Re: In the Matter of PORTLAND GENERAL ELECTRIC CO.  
2016 Integrated Resource Plan  
**Docket No. LC 66**

In the Matter of	)	
	)	
PORTLAND GENERAL ELECTRIC	)	OPENING COMMENTS OF THE
COMPANY	)	INDUSTRIAL CUSTOMERS OF
	)	NORTHWEST UTILITIES
2016 Integrated Resource Plan.	)	
_____	)

Re: LC 66 - Initial Comments on behalf of ICNU on the 2016 Integrated Resource Plan of Portland General Electric Company

Figure 1<sup>37/</sup>

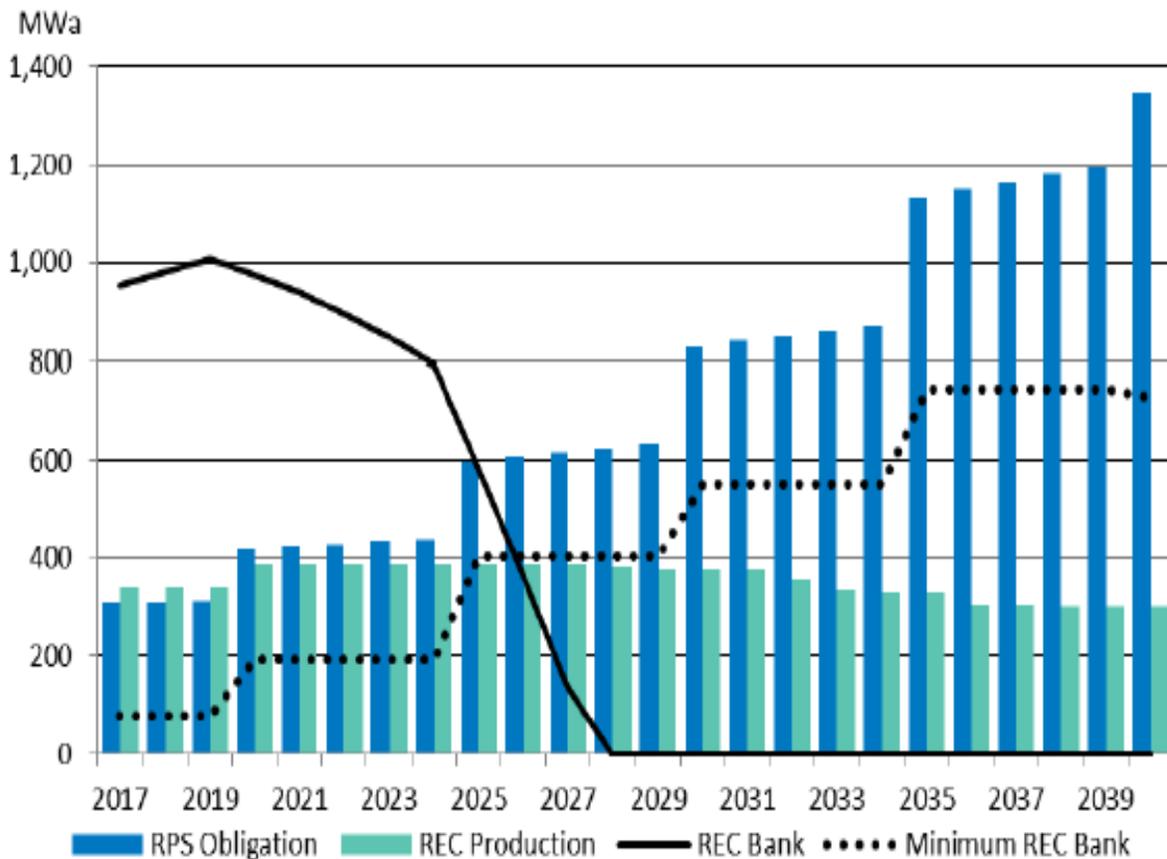
There are a number of problems with the Company's approach. First, the Company's method of calculating its minimum REC bank leads to an excessive number of RECs in the bank. Because the RPS and the Company's load are assumed to increase over time, the amount of RECs needed to maintain the "minimum" level grows significantly until, as can be seen from Figure 1, below, by 2025 the Company must keep more RECs in its bank to maintain its "minimum" than its existing RPS resources generate today.

In other words, under the Company’s methodology, resources customers are paying hundreds of millions of dollars for today in order to ensure the Company’s compliance with Oregon’s RPS will, by 2025, be used for nothing more than a safeguard against the “worst case” outcome.

In the near-term, the appropriate “minimum” number of RECs to keep in the bank is immaterial. Figure 1, above, shows that PGE has far more RECs in its bank currently than it needs to comply with the RPS in the near-term. ICNU, therefore, recommends that PGE eliminate its minimum REC bank requirement and reevaluate it in future IRPs when the issue is more relevant.
